**Subject: Clarification of NFS' Responses to the RAI Supporting NRC's Environmental
Review for the BLEU Project**

***Clarification of NFS' Responses to the Request for Additional Information
Supporting NRC's Environmental Review for the BLEU Project***

Updated Drawing Including Locations for Former Wells SC-7 and 82

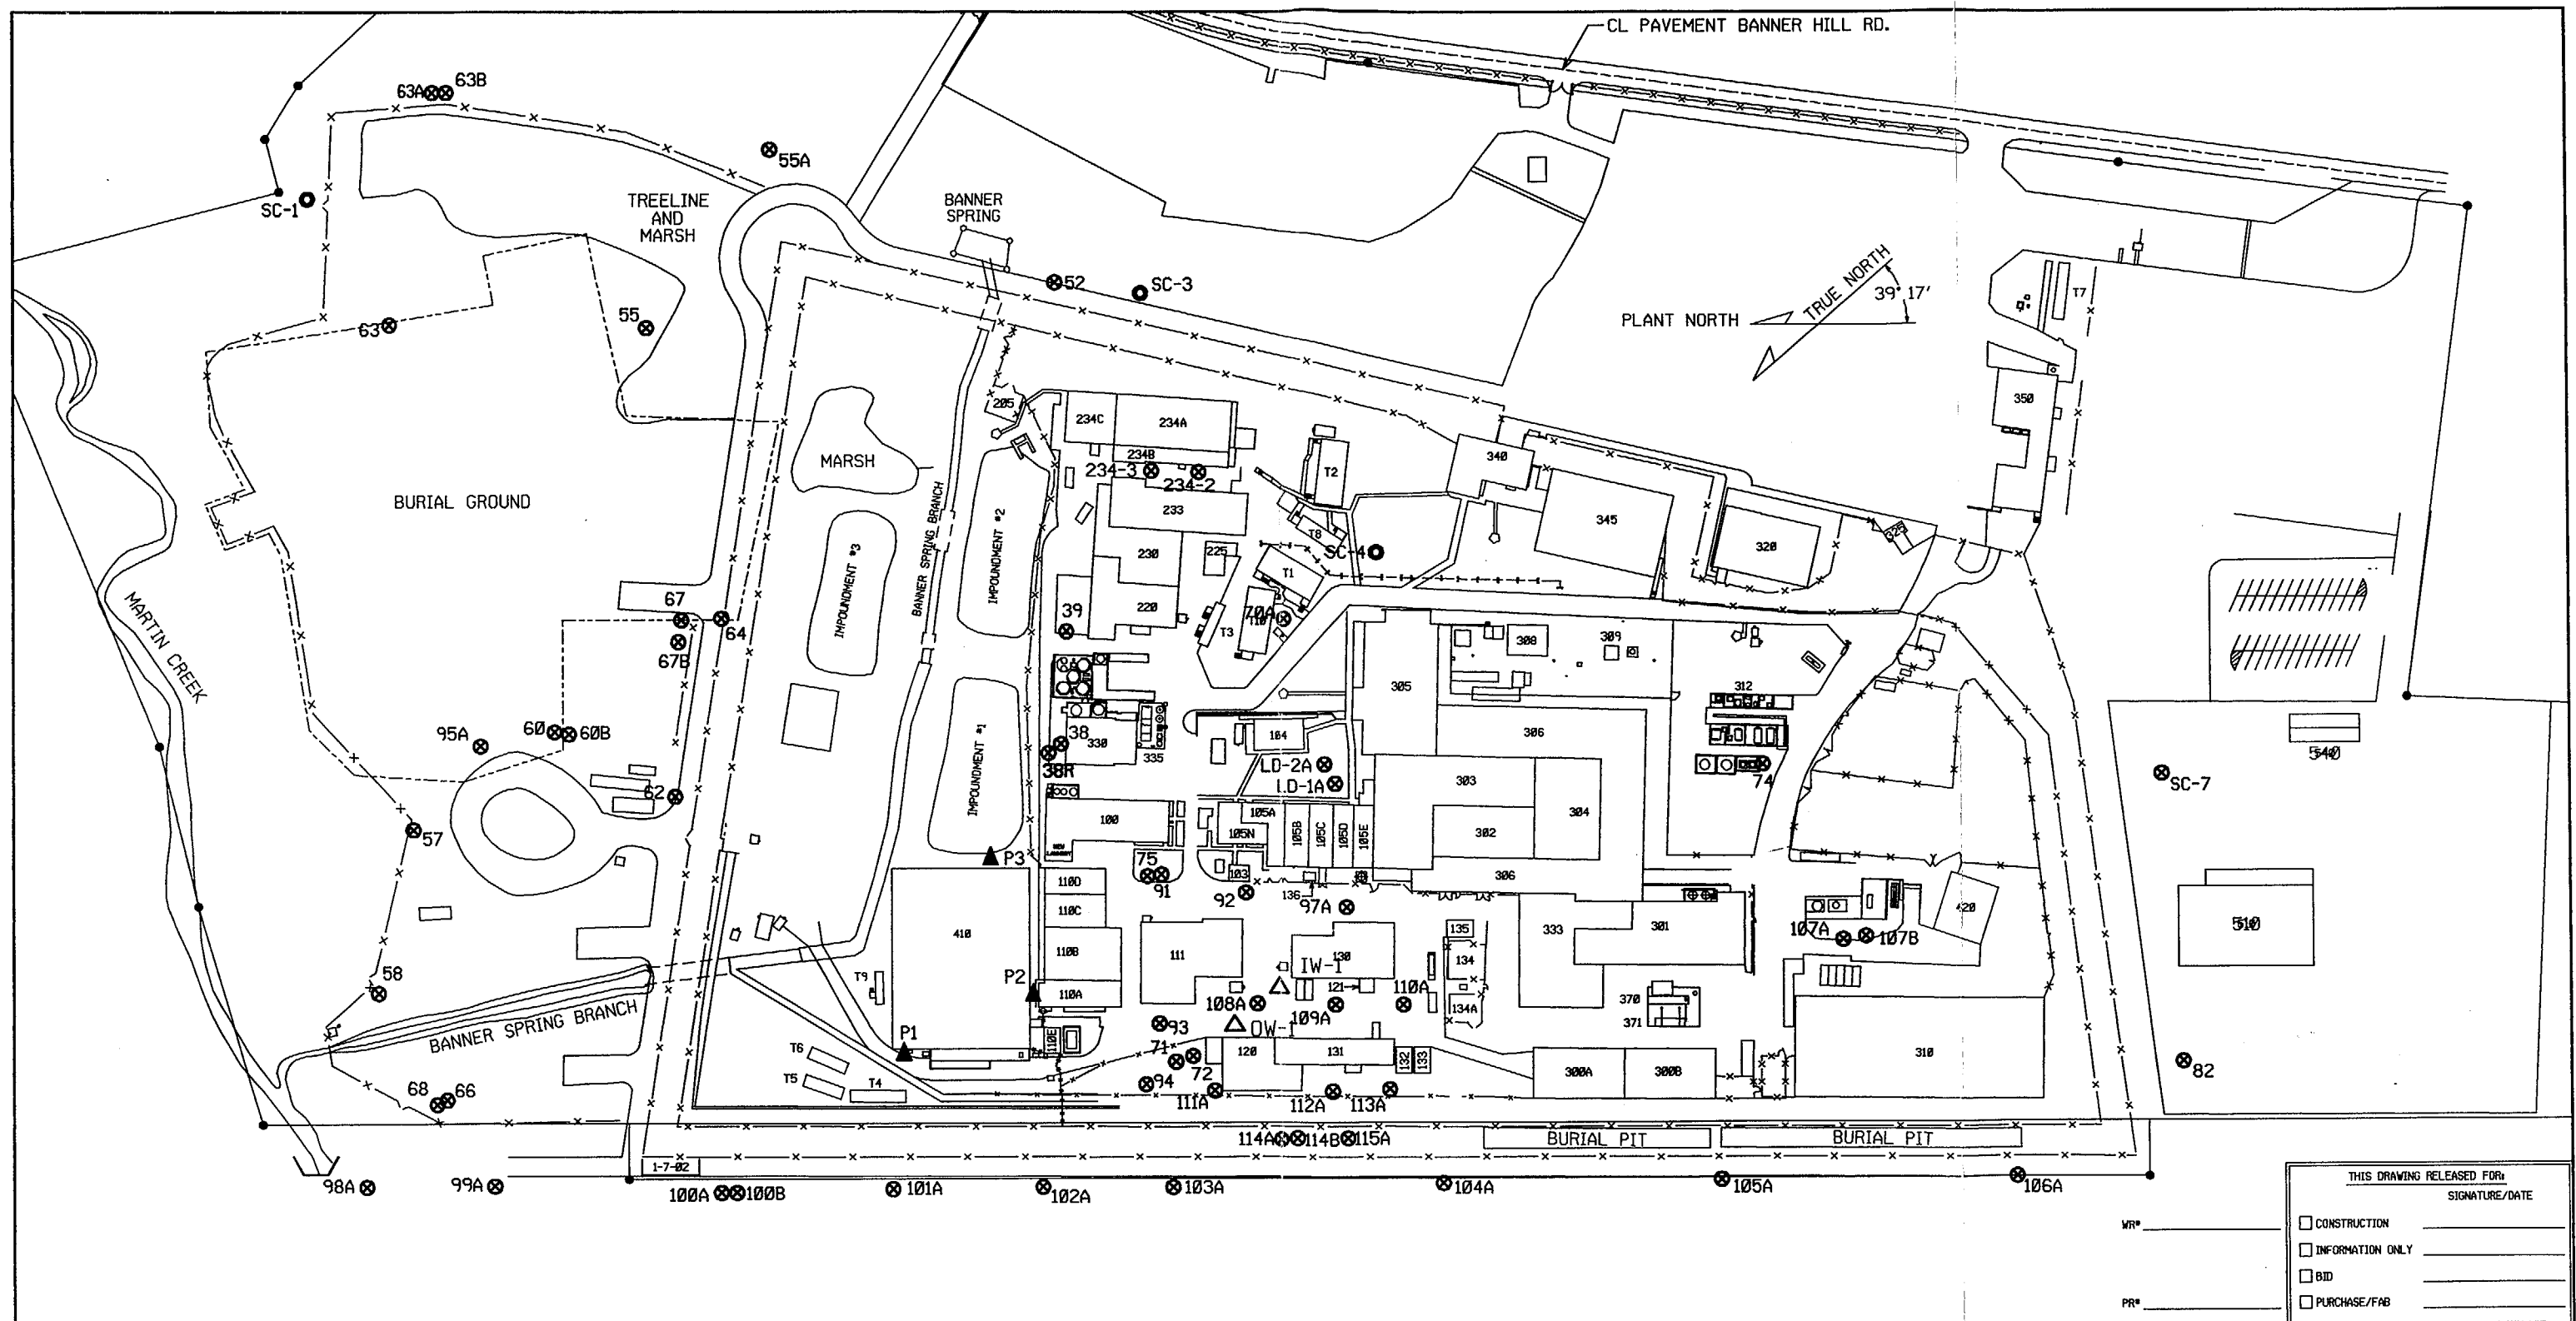
NRC Comment 1: (RAI 7b) Some existing wells are missing from the current chart of groundwater monitoring wells. Even though NFS will propose new monitoring locations in the future (post EA), for the EA we requested an updated chart with the correct information. They [NFS] agreed to provide.

NFS Response to Comment 1: Attachment V of the RAI Responses¹ provided a drawing that depicted monitoring wells locations at the NFS site including the BLEU Complex. There had been two wells, SC-7 and 82, on the land for the BLEU Complex. They were abandoned in August 2001 and, thus, were not included on the drawing. This drawing has been amended to show the former locations for wells SC-7 and 82 and is Attachment II of this submittal.

SC-7

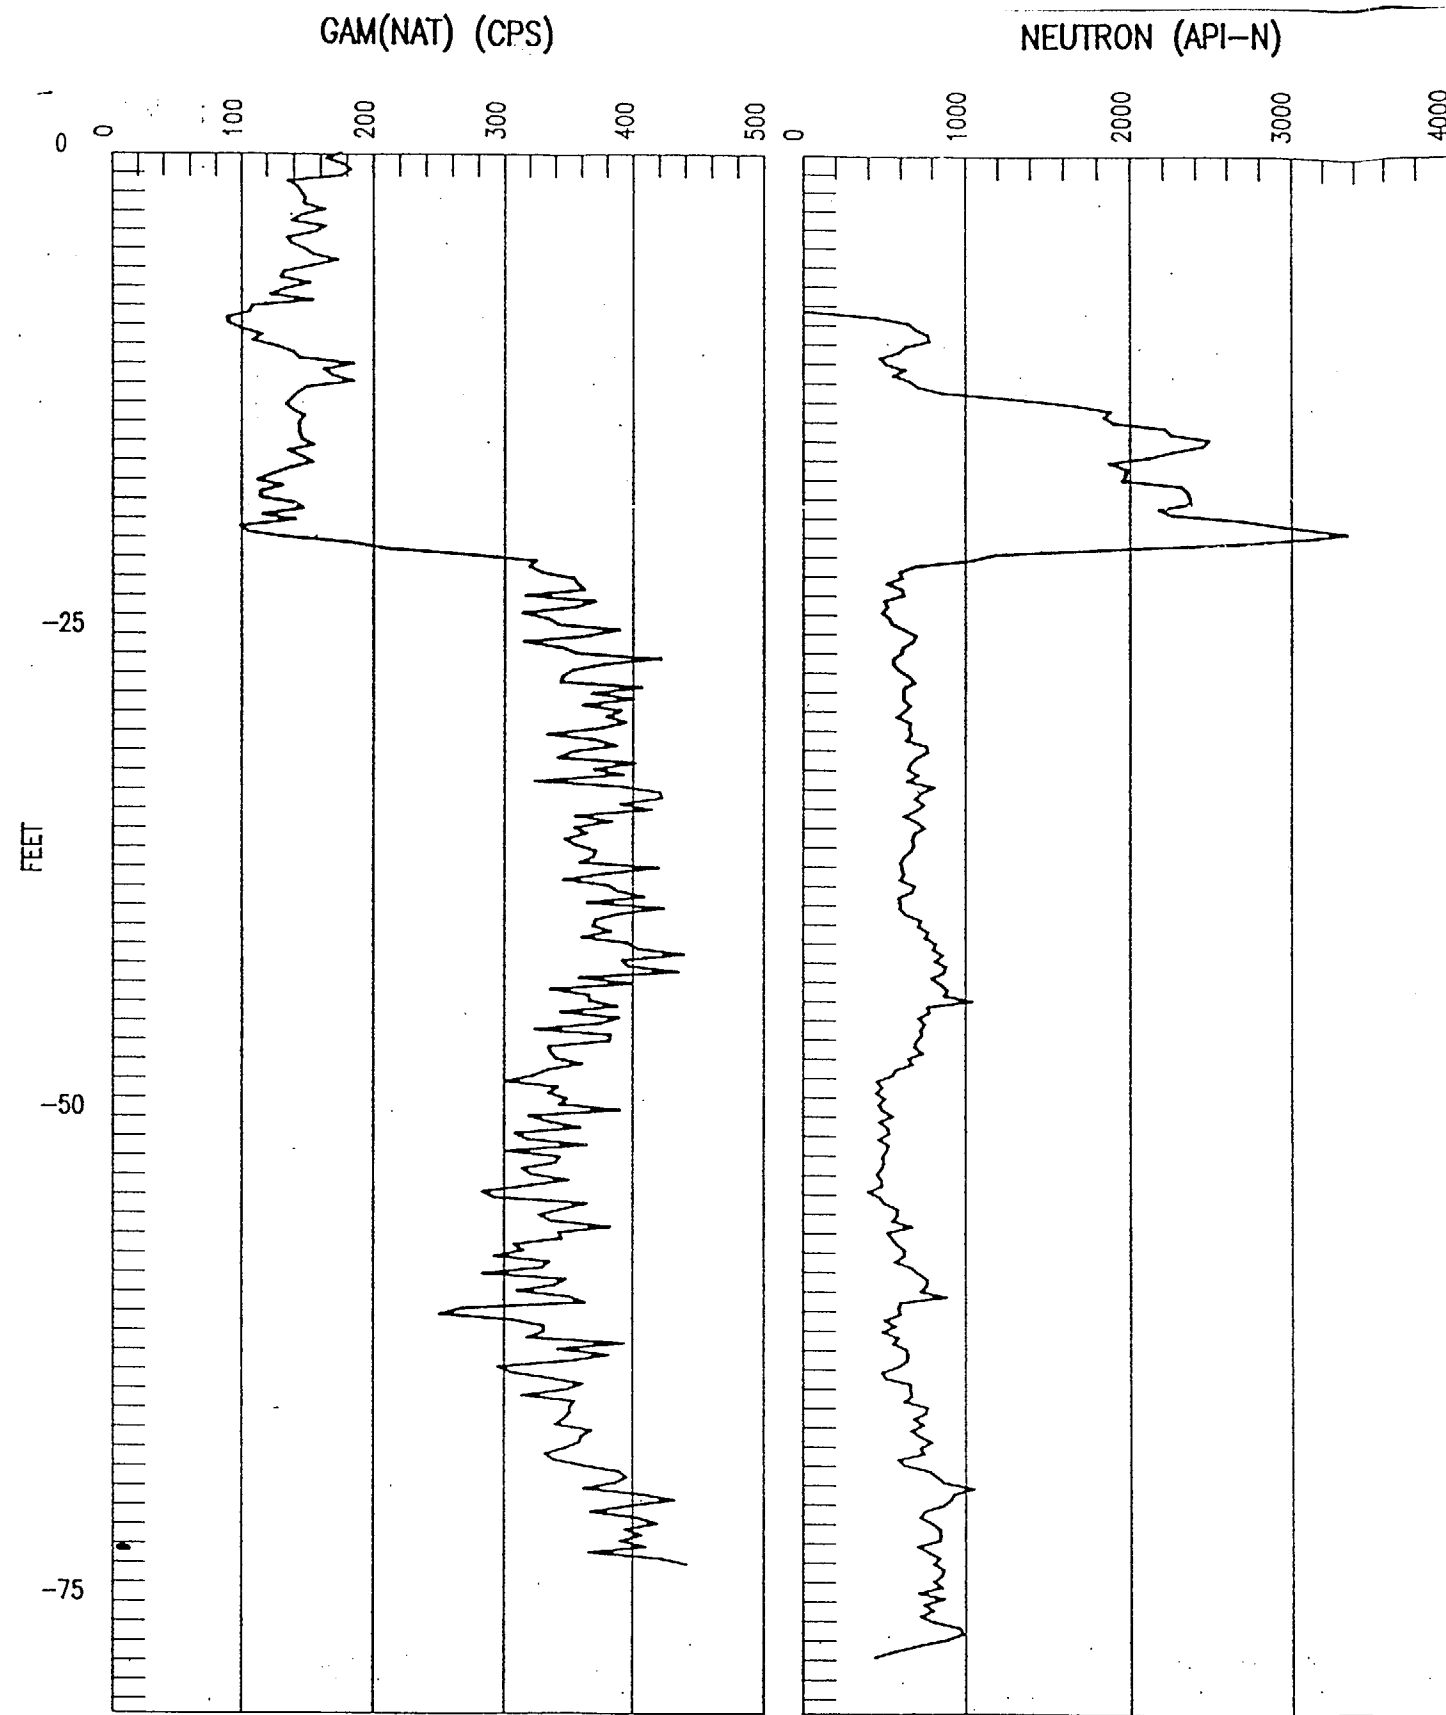
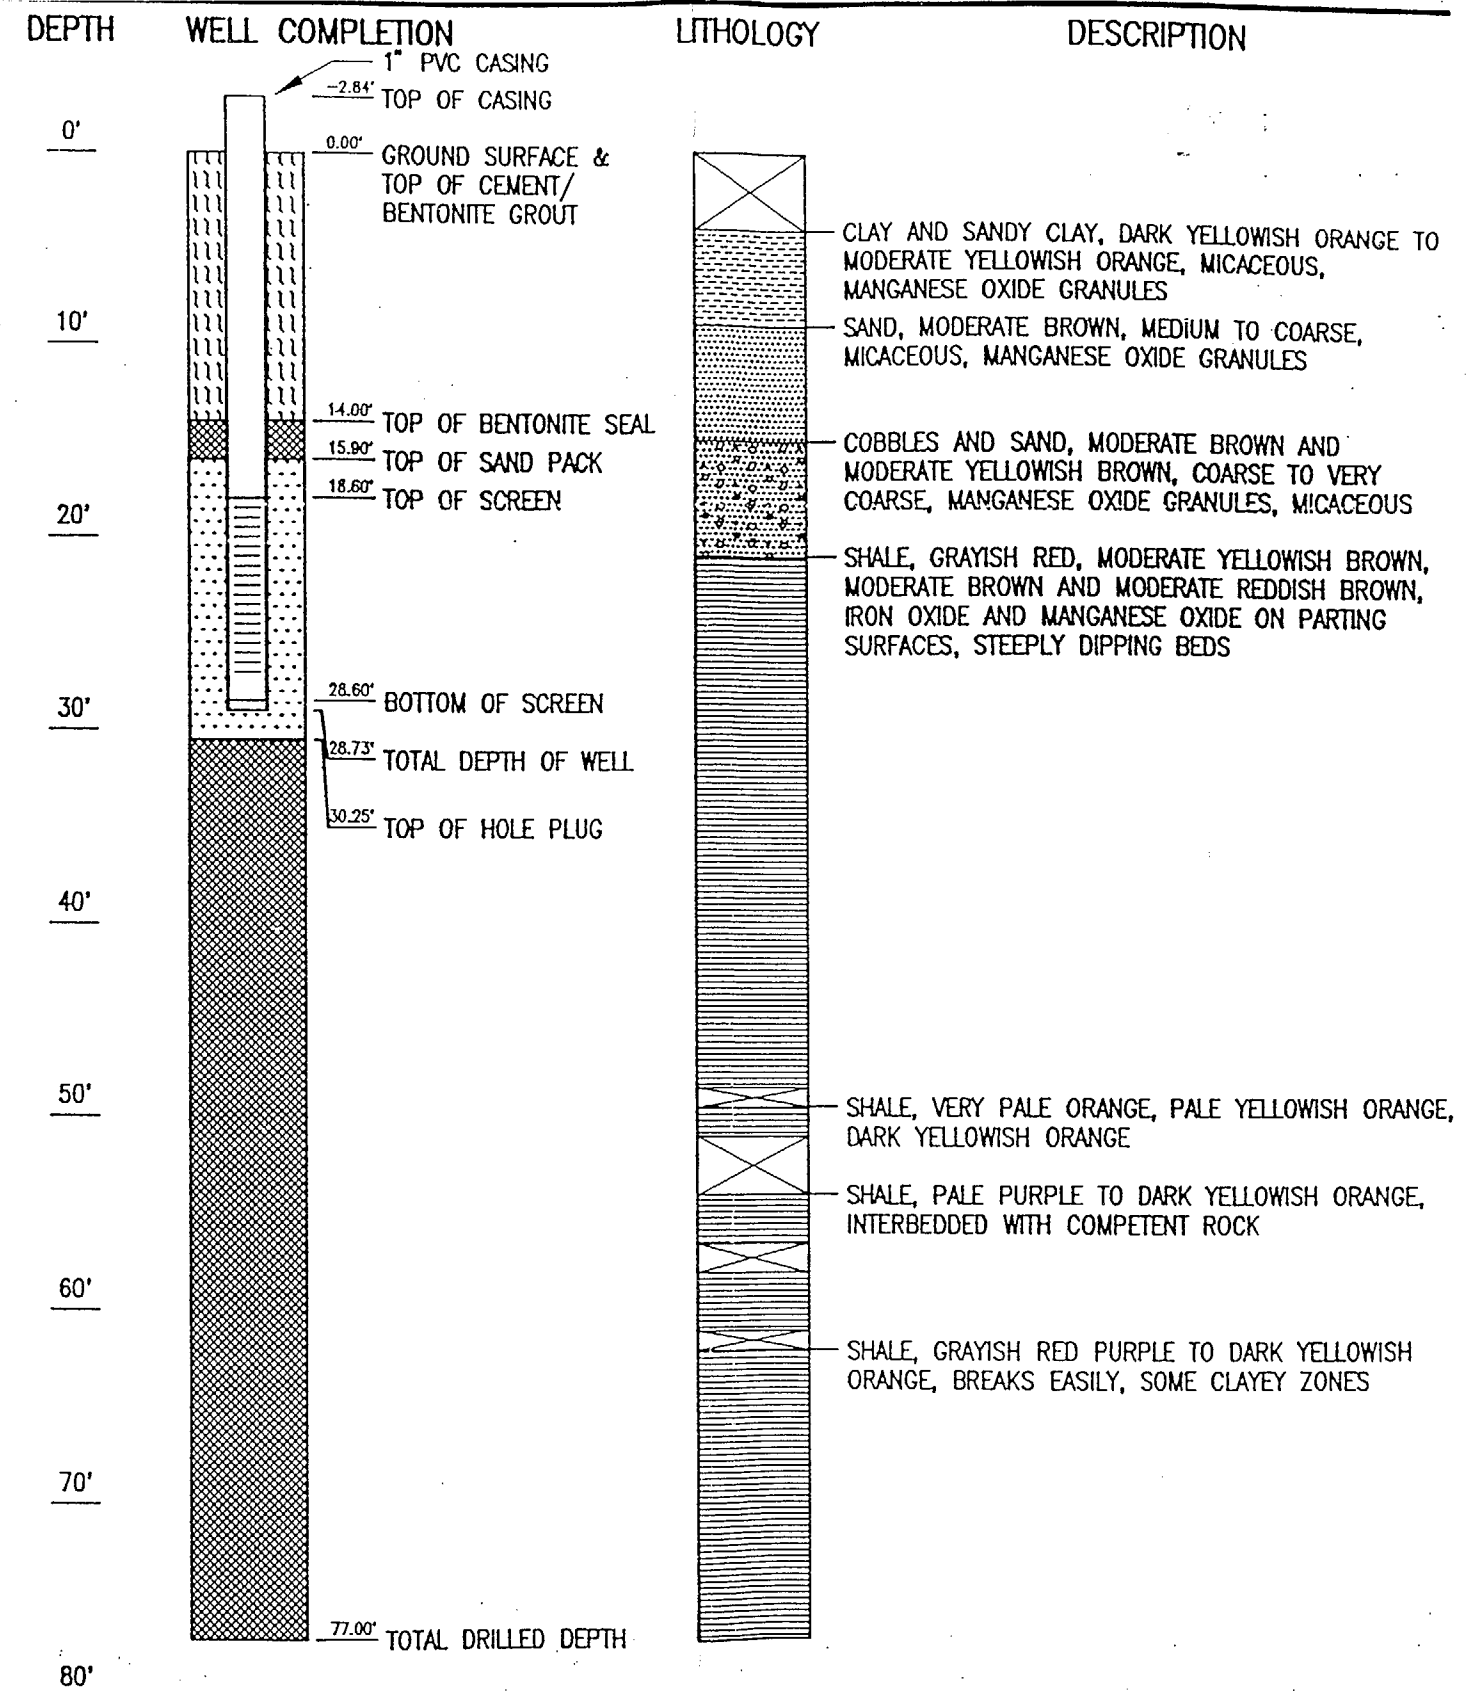
NRC Comment 3: (RAI 21) Information on the hydrology at the proposed BLEU Complex location that was discussed during the last meeting was not included in the RAI package. This includes zone depths, water levels, brief info generally describing that a baseline characterization would be done. NFS agreed to provide.

NFS Response to Comment 3: Attachment III of this submittal provides boring logs, well installation diagrams, and water level data for wells SC-7 and 82 that were located on the proposed BLEU Complex site. A description of the baseline characterization is provided in the response to Comment 5.
